SUBJECT: **R.E. Ginna Nuclear Power Plant**
Docket No. 50-244

Request For Additional Information Regarding Generic Letter 2004-02

Ginna LLC Response to Request for Additional Information
Regarding GL 2004-02, Dated December 4, 2009

Figure 1.2.2 – Ginna Steam Generator Compartment Grating

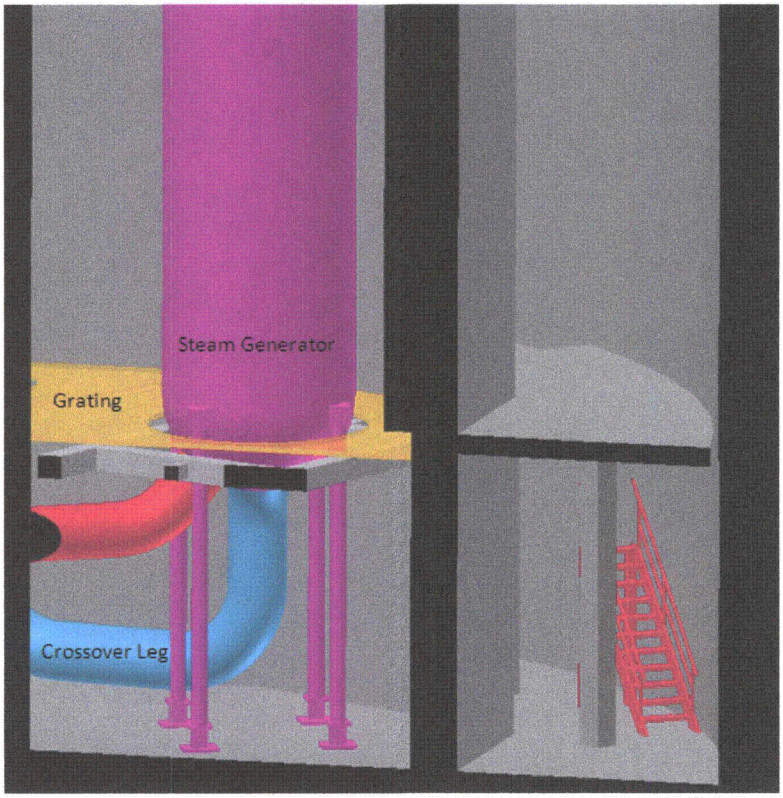
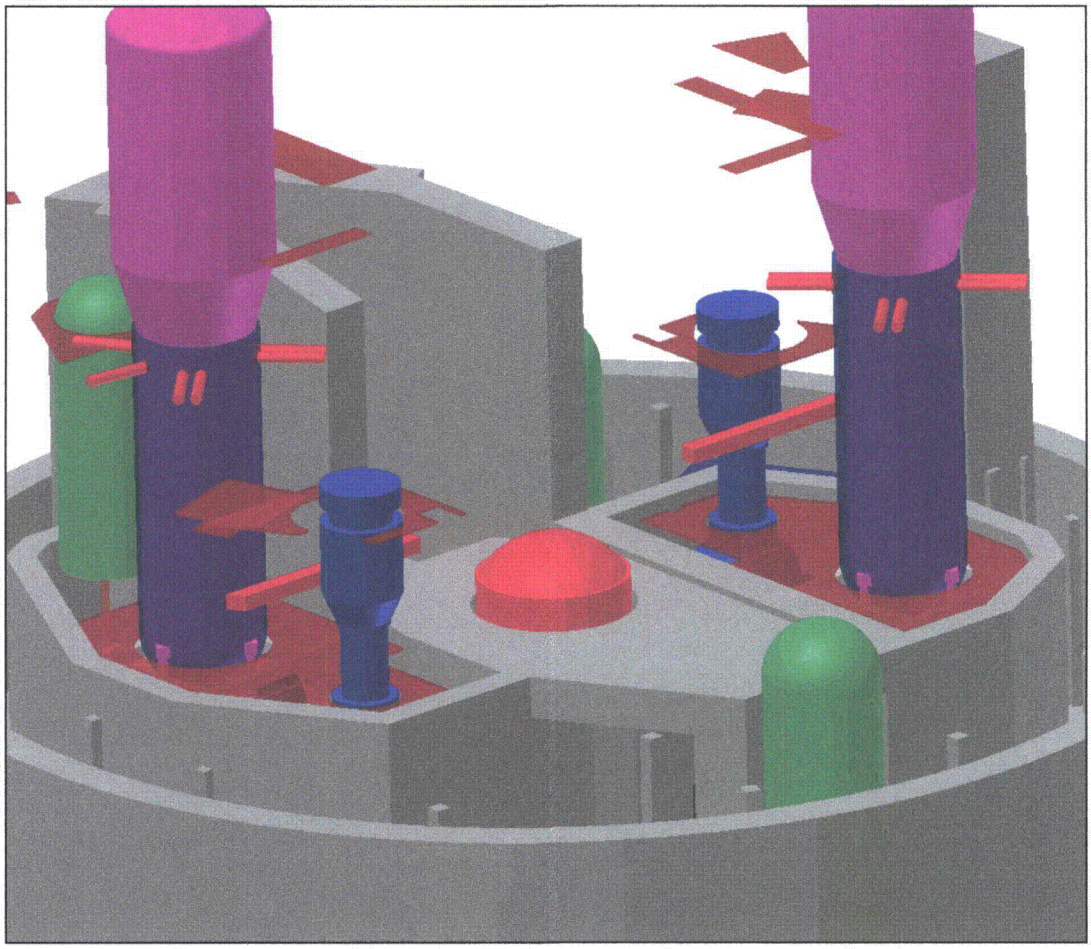
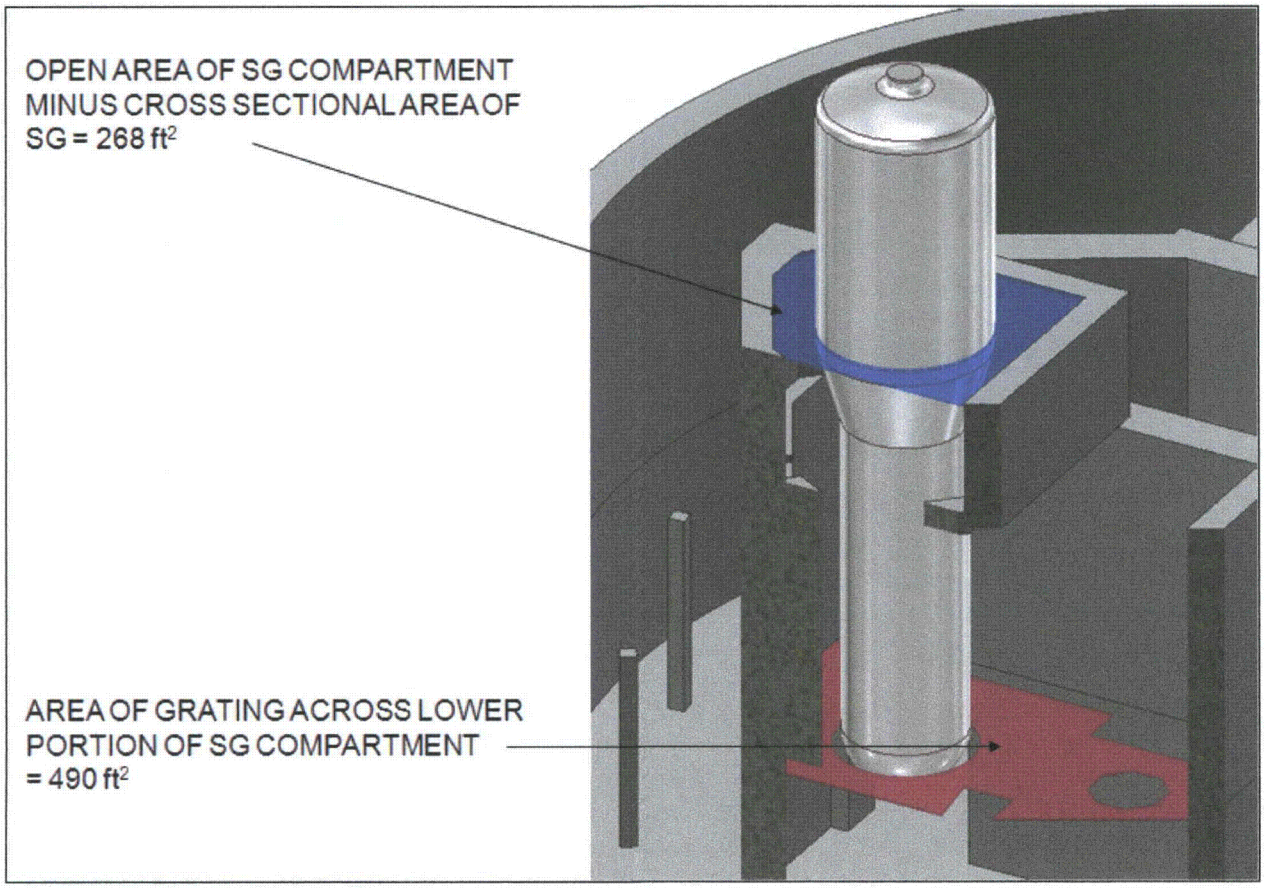
Based on the information provided in the June 2, 2009, supplemental response, it appeared that 3% of small pieces and 37% of large pieces of fibrous debris were assumed to be trapped on gratings during the blowdown phase. Please clarify whether the grating credited with this debris capture is located below postulated break locations, and provide a technical basis (e.g., specific tests from which data was applied) to justify the assumed capture fractions.

There was no credit taken for debris remaining captured on grating below the postulated break locations as there is no grating underneath the break location. The configuration at Ginna is such that the break location is below the grating (on the crossover leg), but the majority of the insulation that could be potentially blown off of the steam generator is above the grating. Thus, no debris held up on grating was credited with being captured below the break location. A cutaway view of a steam generator compartment at Ginna is shown below in Figure 1.2.1.

There is no significant grating at the top of the SG compartments at Ginna. Based on this, the percentage of small piece fibrous debris that would be blown to upper containment can be calculated as shown below:

As shown in Figure 1.2.2, grated platforms exist low in the steam generator compartments at Ginna covering a large portion of the compartment area. In the transport analysis, the grating was conservatively assumed to only cover 50% of the compartment. The grating would capture some of the small and large debris not blown to upper containment. All of the debris not transported to upper containment was conservatively assumed to be blown toward the floor (in reality some of the debris would be lodged in structures around the compartment). Based on this, the percentage

It's possible that a small amount of the captured fiber could be washed down by containment sprays during the brief duration that the sprays are in operation. However, less than 55% of the grating near the base of the steam generator compartment (where debris retention was credited) is exposed to sprays as shown in Figure 1.2.3. Since it was very conservatively assumed that the grating covers only 50% of the compartment area when it actually covers close to 100% of the area, any washdown that occurs due to sprays is more than compensated by the conservatism. For example, if the full 100% grating coverage was credited, the percentage of small fiberglass debris captured would be doubled to 6%. Based on drywell debris transport study testing, washdown of small fiberglass due to containment sprays is likely less than 50%. However, even if 100% of the small fiberglass exposed to sprays on the grating is washed down, the retention of small fiberglass on grating in the steam generator compartment would still be approximately 3%. Therefore, the retention fraction that was credited is conservative.

Figure 1.4.1 – LANL LBLOCA Progression Excerpt

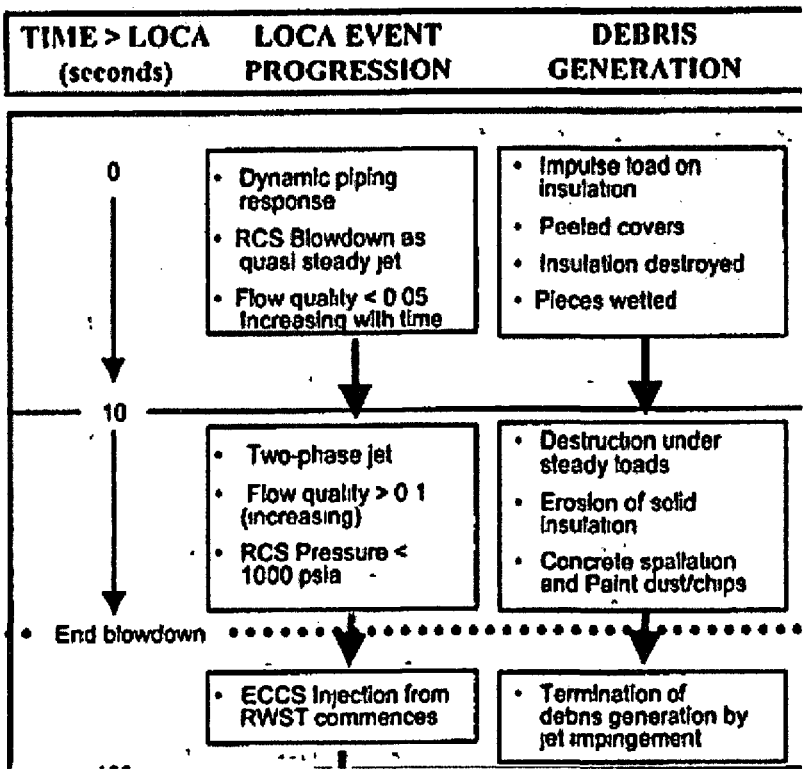
b) The methodology assumed that the small pieces of fibrous debris would be saturated with water. The basis for this assumption is unclear, given that the fraction of small pieces of fiber that was fragmented and blown to the upper containment would have been impacted with a two-phase jet that had largely flashed to steam before contacting the insulation. Furthermore, the water on the operating deck would largely be spray drainage at cooler temperatures, which does not rapidly penetrate insulation debris due to its viscosity. In addition, on the upper level, the debris pieces would not be fully submerged. Accounting for trapped air in small pieces of fibrous insulation would lead to increased tumbling transport versus the licensee's evaluation, and also to the consideration of the potential for transport via floatation, which did not appear to have been evaluated due to the assumption of the debris being water saturated.

This LANL description suggests that the fluid from a break would be in the form of small droplets that would wet the insulation as it was destroyed. The large break LOCA accident progression scenario is illustrated in Figure 12 of the LANL report. The portion illustrating the first few seconds of the accident sequence associated with debris generation is reproduced in Figure 1.4.1.

Figure 1.8.1 – Reactor cavity area

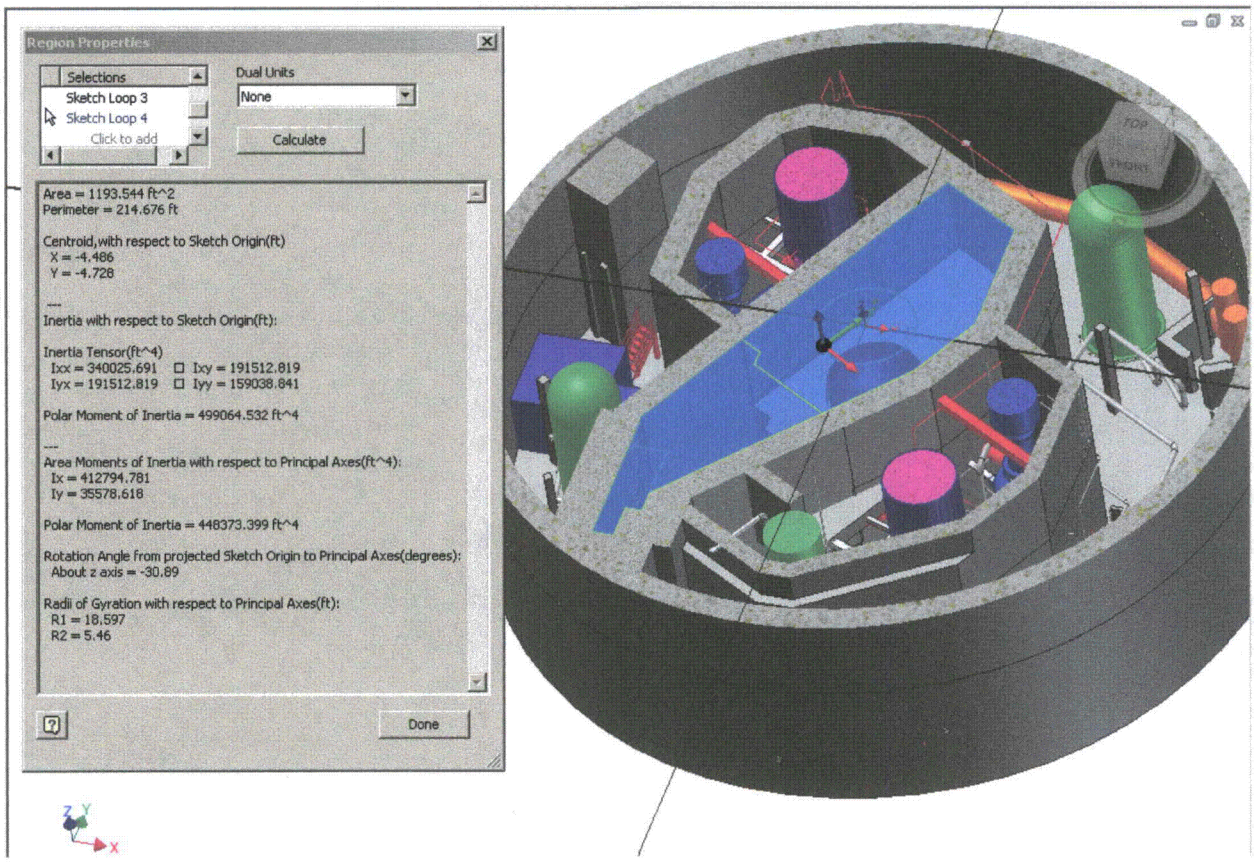
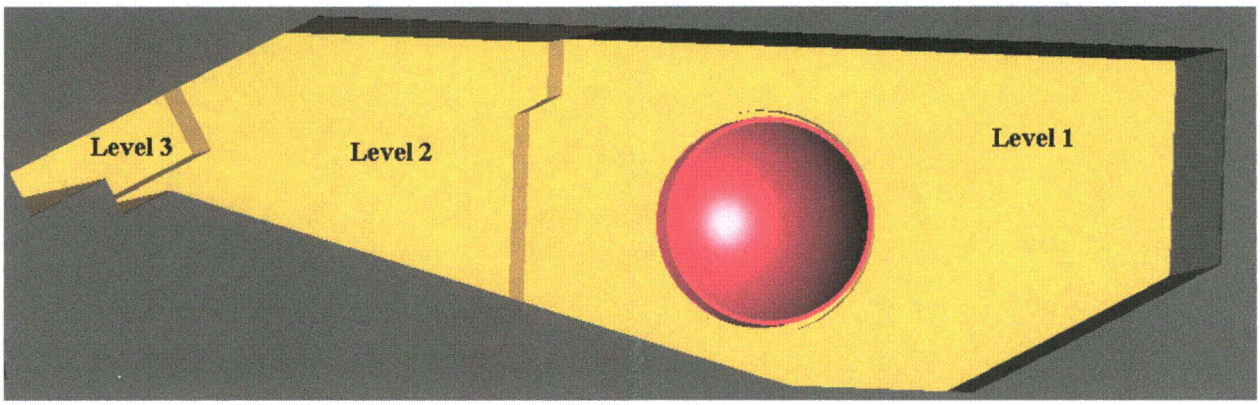
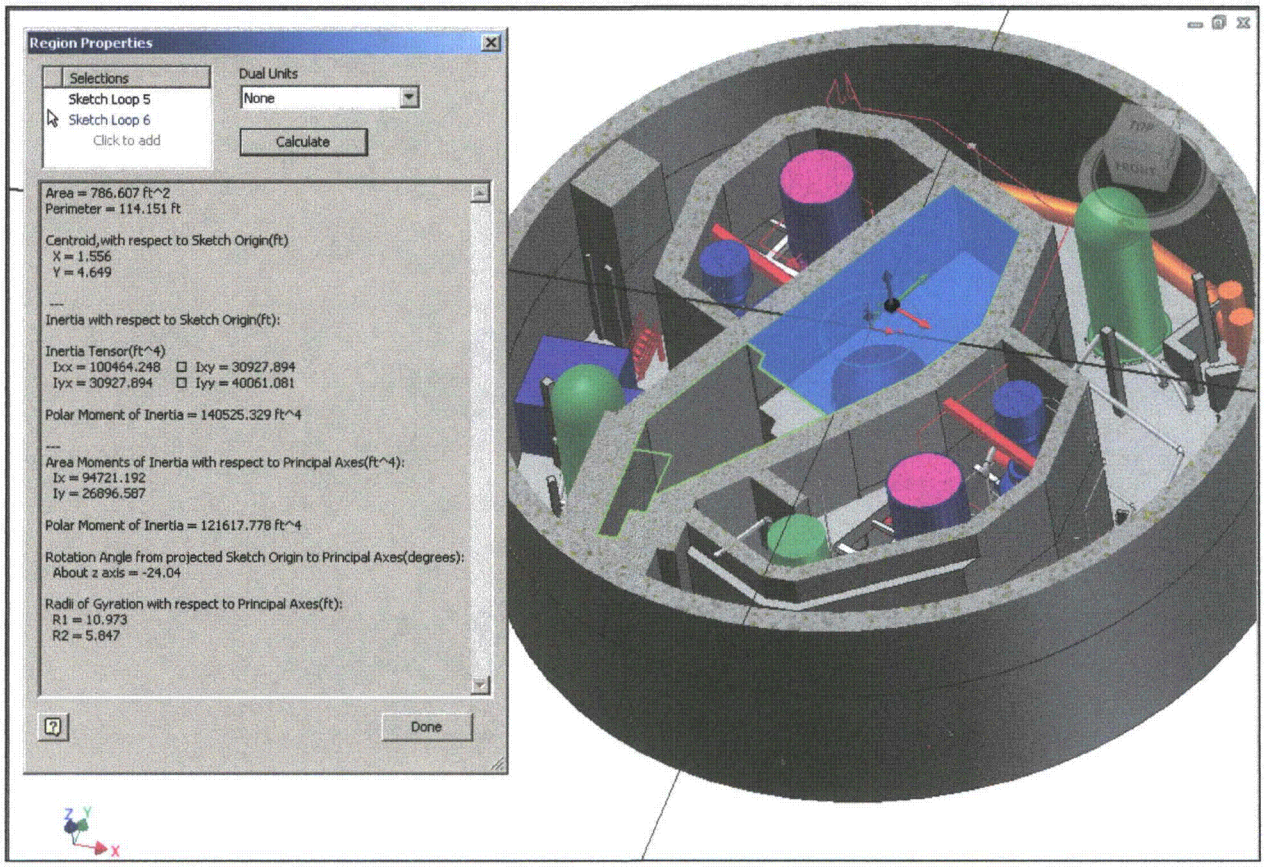
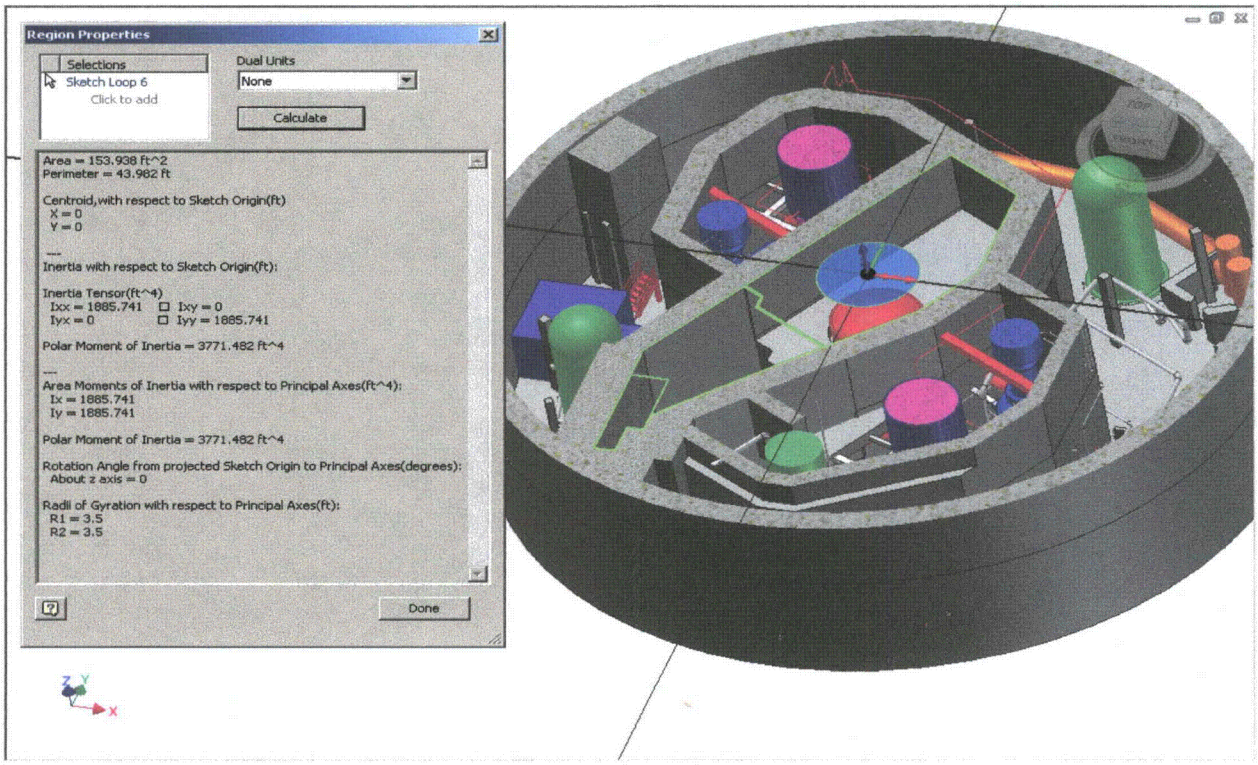
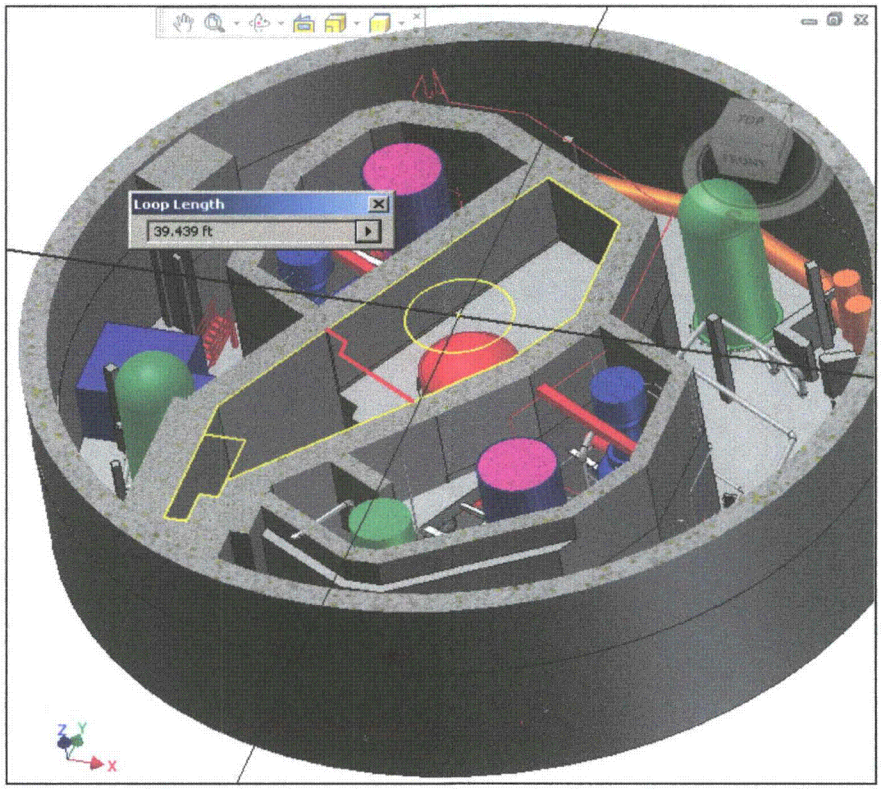
The June 2, 2009, supplemental response stated that any debris washed to the refueling cavity would be held up in the refueling cavity or reactor cavity rather than reaching an active portion

of the containment pool. Please clarify whether filling of the inactive volumes prior to the termination of the containment sprays could occur for any post-LOCA scenarios, resulting in a portion of the debris assumed to wash to the inactive volumes reaching the active containment pool instead.

The maximum volume of spray flow that would be delivered over the 57.56 minutes that the containment spray pumps are running would be 133,172 gallons, which yields an average flow rate of 2,314 gpm [4]. The refueling canal area was calculated to be 1,194 ft^2 (see Figure 1.8.1) and the cross sectional area of containment was calculated to be 8,669 ft^2 [4].

The remaining containment spray flow rate of (2,314 gpm – 1,995 gpm) 319 gpm would be delivered to the refueling canal. The refueling canal is divided into levels as shown below in Figure 1.8.2. Level 1 is the highest level around the reactor vessel head, level 2 lies below level 1, and level 3 below level 2. All of the debris and water landing on level 1 has the potential to either wash down the side of the reactor (to Sump A), or down to level 2. Any spray flow arriving in level 2 or 3 remains trapped in place (an inactive cavity).

Level 1 has a total area of 787 ft^2 (Figure 1.8.3) out of the total refueling canal area of 1,194 ft^2.

The water and debris in level 1 of the refueling canal has two locations that it can flow to. It can flow down the side of the reactor vessel (which has a total perimeter of 44 ft, Figure 1.8.4) to Sump A or past the reactor vessel down to level 2 (which has a perimeter of 39 ft, Figure 1.8.5) as shown in Figure 1.8.2.

Using a ratio of perimeters [44 ft / (44 ft + 39 ft)], 53% would travel down the sides of the reactor vessel to Sump A and 47% would travel down to level 2 of the refueling canal.
